LETTER 8

NOTE: The submitted letter is a compilation of text, photographs and images that is not presented in a typical “letter” format. Given the size and amount of photos, a black-and-white copy has been produced for this FEIR, but the full color version is available for review on the City’s website, at the City of Santa Cruz Planning and Community Development Department, and at the Santa Cruz Public Library, downtown branch.² A good faith effort has been made to respond to significant environmental issues raised. It is also noted that the commenter includes multiple references to General Plan, Local Coastal Plan (LCP) and/or Beach and South of Laurel Comprehensive Area Plan (B/SOL Area Plan) policies and text that are often outdated and/or incorrectly cited. For example, the City adopted an updated *General Plan 2030* in 2012 that supersedes General Plan policies contained in the former *General Plan/LCP 1990-2005* document, although the LCP policies in the 2005 document remain in effect. Additionally, many cited page numbers and other citations to the B/SOL Area Plan and B/SOL Plan Design Guidelines appear to be taken from earlier draft versions of the plan and not from the fi

APPROVED LA BAHIA

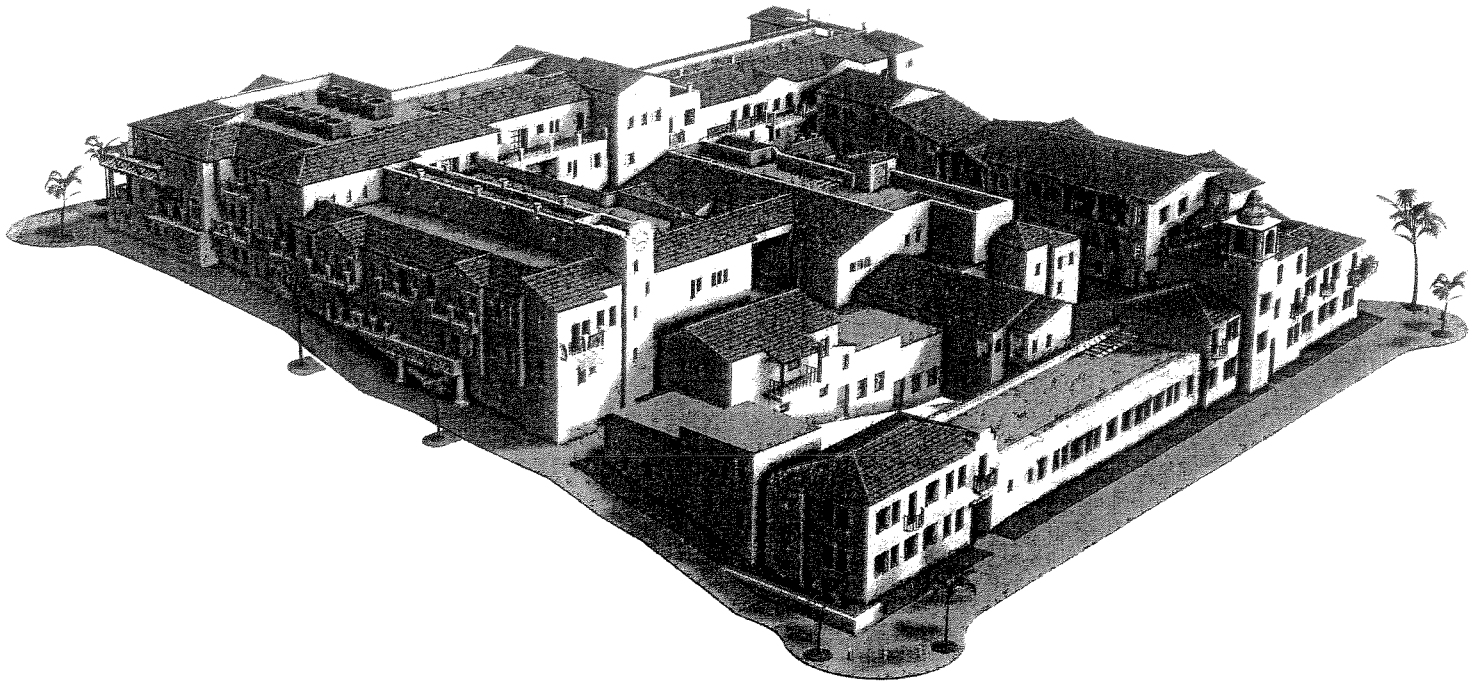
SEVEN HPC CONCERNS OVER
THE FIRST APPROVED DESIGN

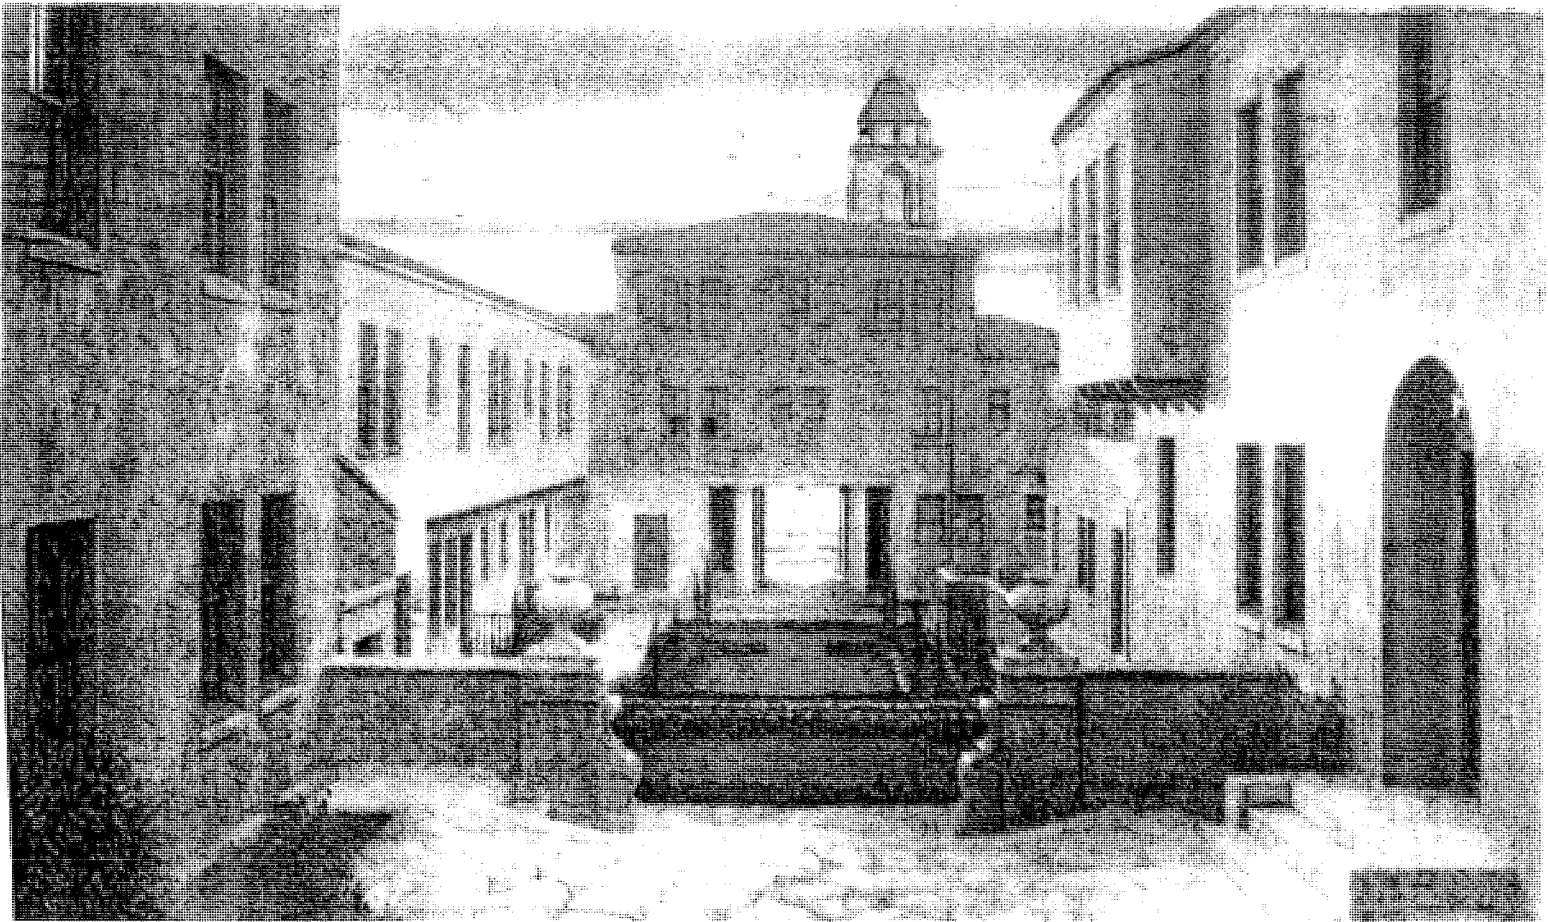
VILLAGE CONCEPT COMPROMISED: In places (like the rear elevation), the proposal has designed the structure to look like one large building, instead of a cluster of small ones. This loses the rare Village Complex characteristic.

ASYMMETRY LOST: Rear elevation and identical paired skyscrapers are designed with ink-blot symmetry, losing the sense of spontaneous construction. The King Builders' proposal was criticized for mass-producing rows of identical wings like modern tract housing units.

TERRAIN LOST: Two looming identical towers both the same size, do not express the hillside terrain.

COURT OF THE LAURELS
(IDENTICAL SCALE OF PICTURE ABOVE & BELOW)

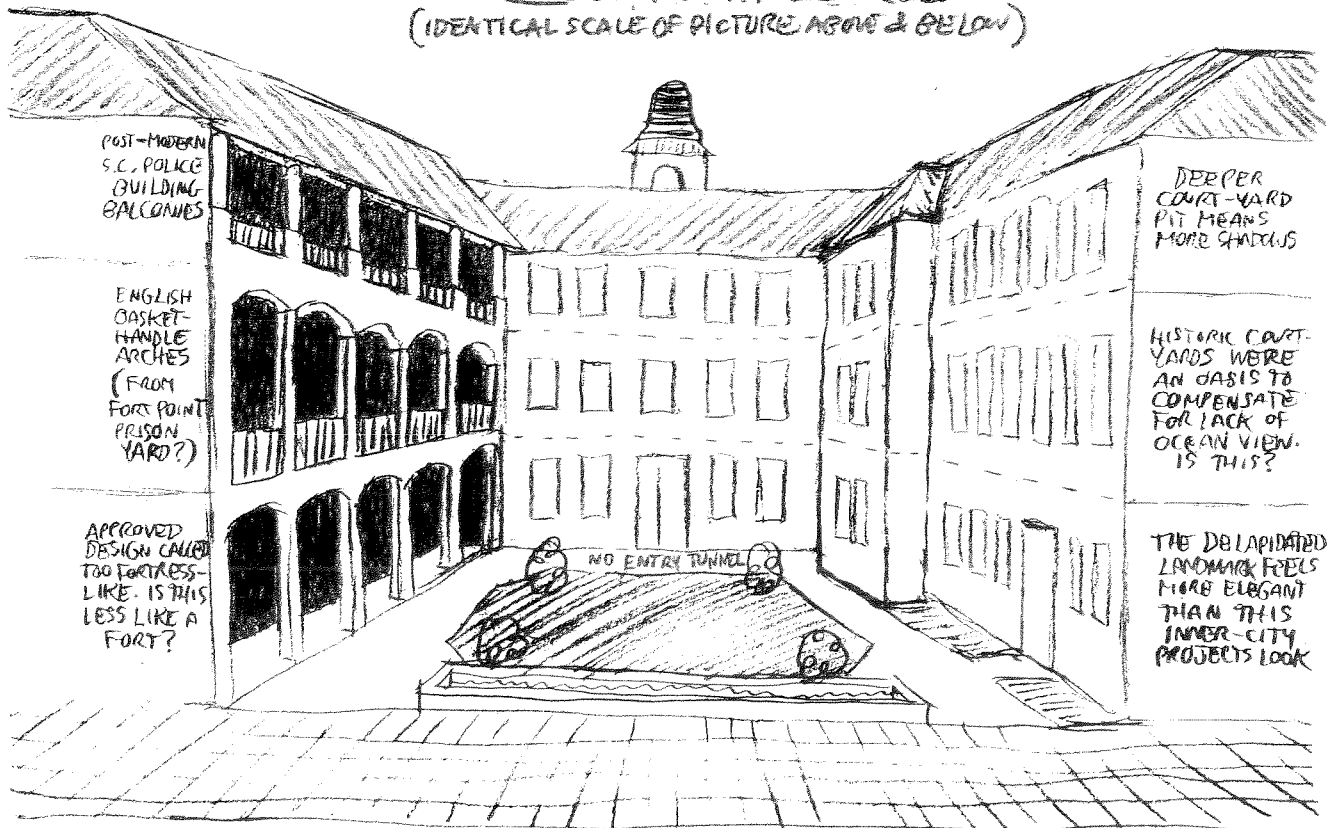
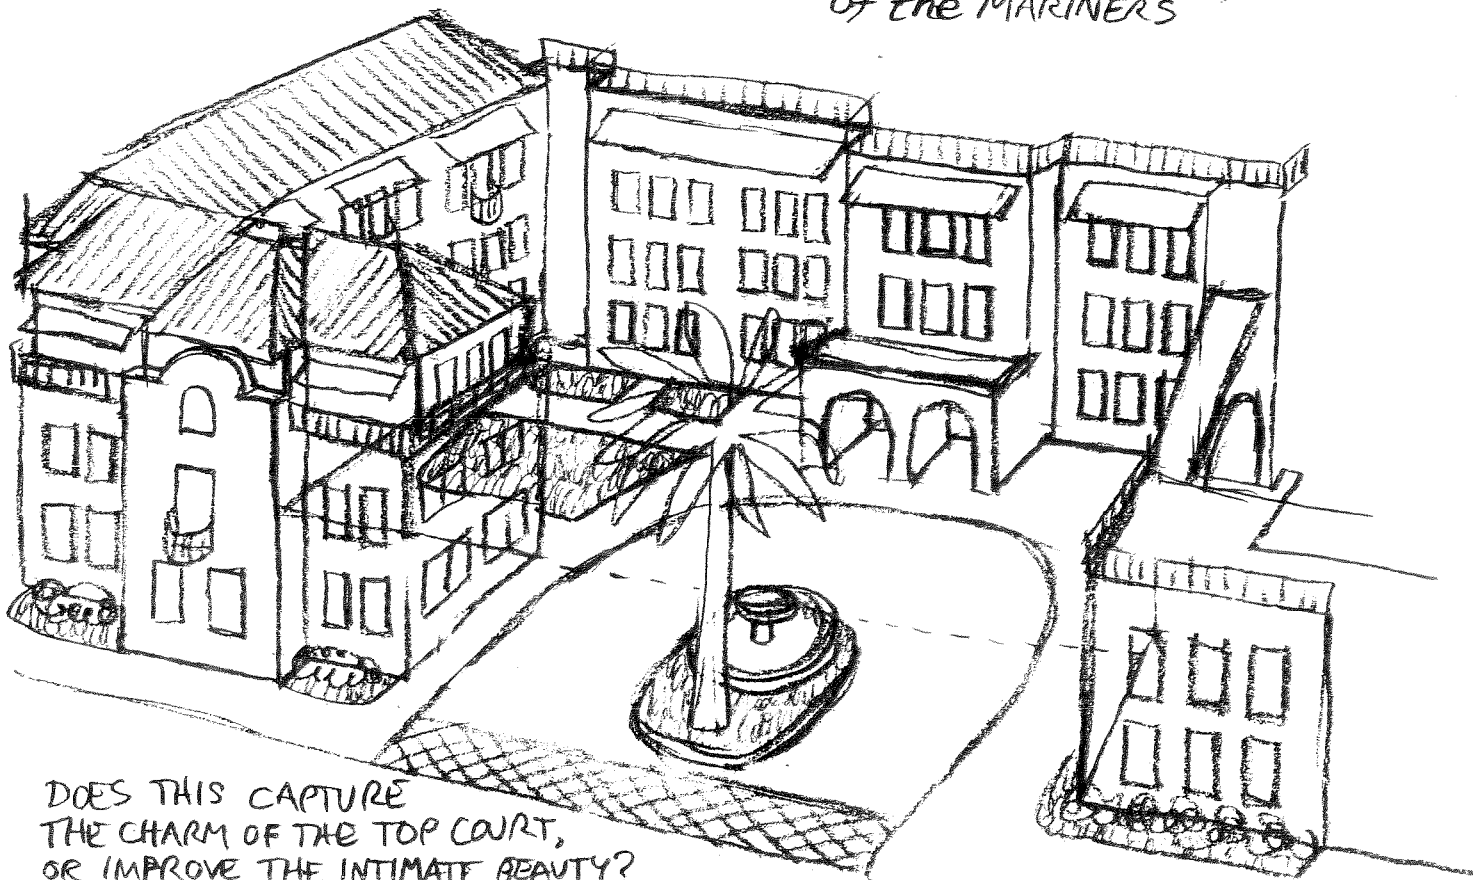
NEW "COURT OF THE LAURELS"
SHORTER LENGTH, TALLER, & WITHOUT TERRACES.

DOES THIS CAPTURE
THE CHARM OF THE TOP COURT,
OR IMPROVE THE INTIMATE BEAUTY?
